Cimarron Hills SE MU
"Hillpointe"

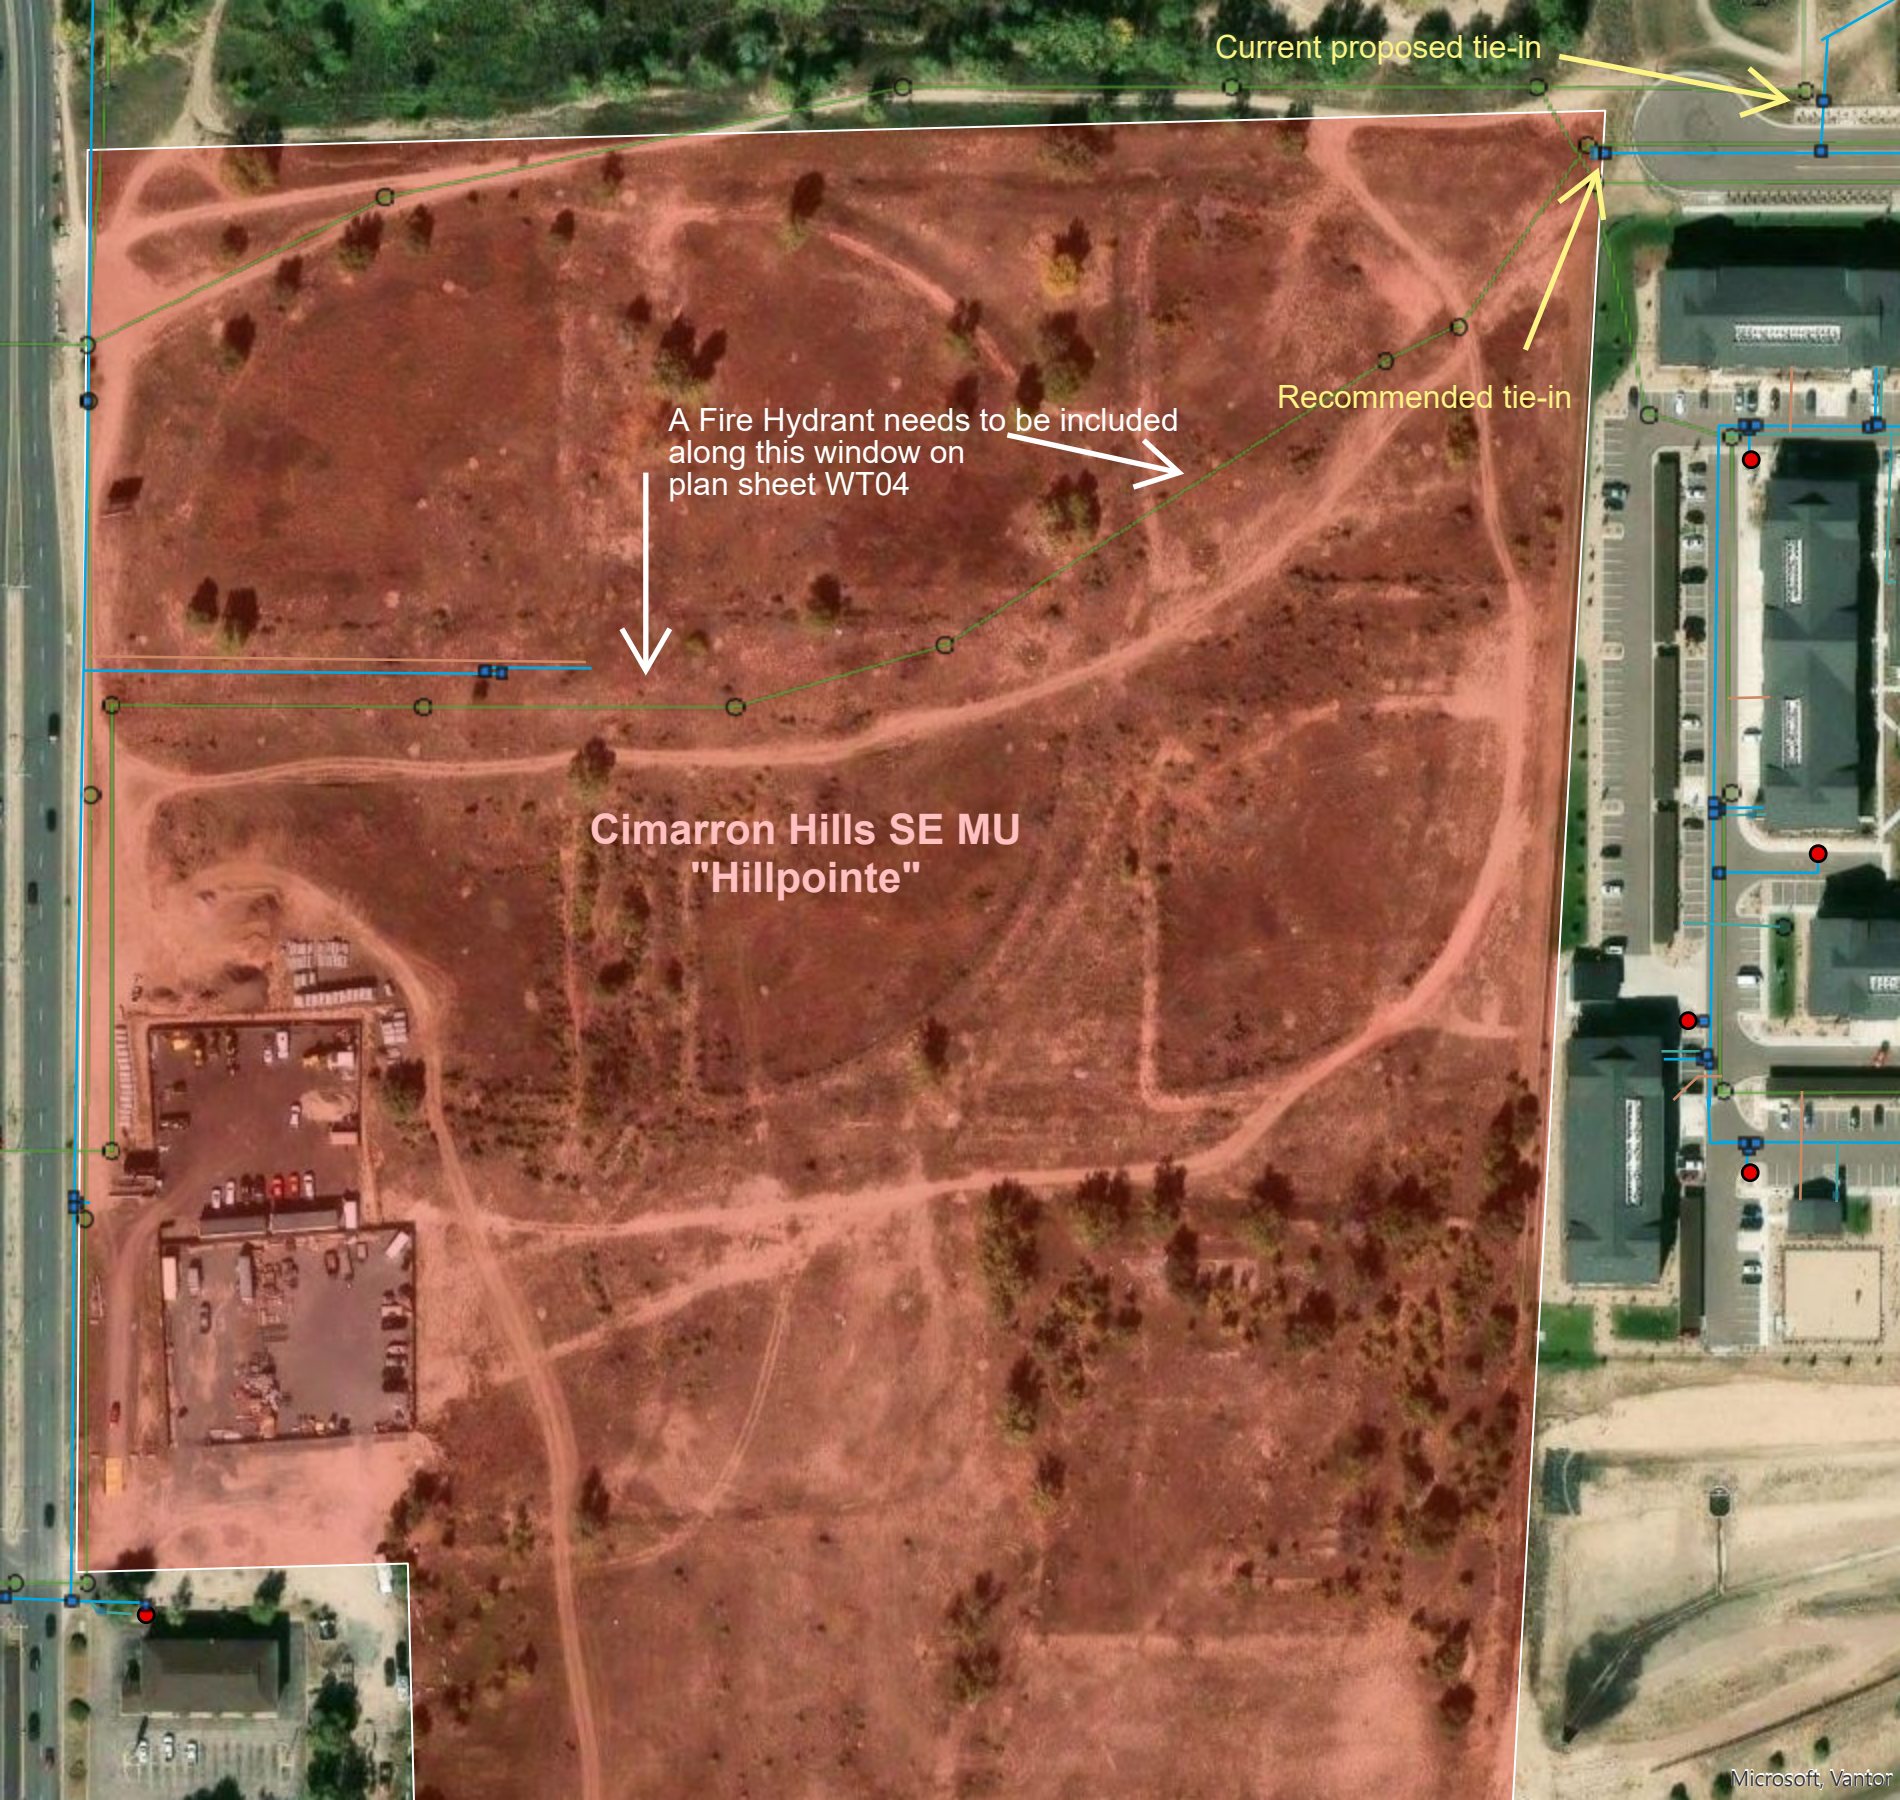
Current proposed tie-in

A Fire Hydrant needs to be included
along this window on
plan sheet WT04

Recommended tie-in
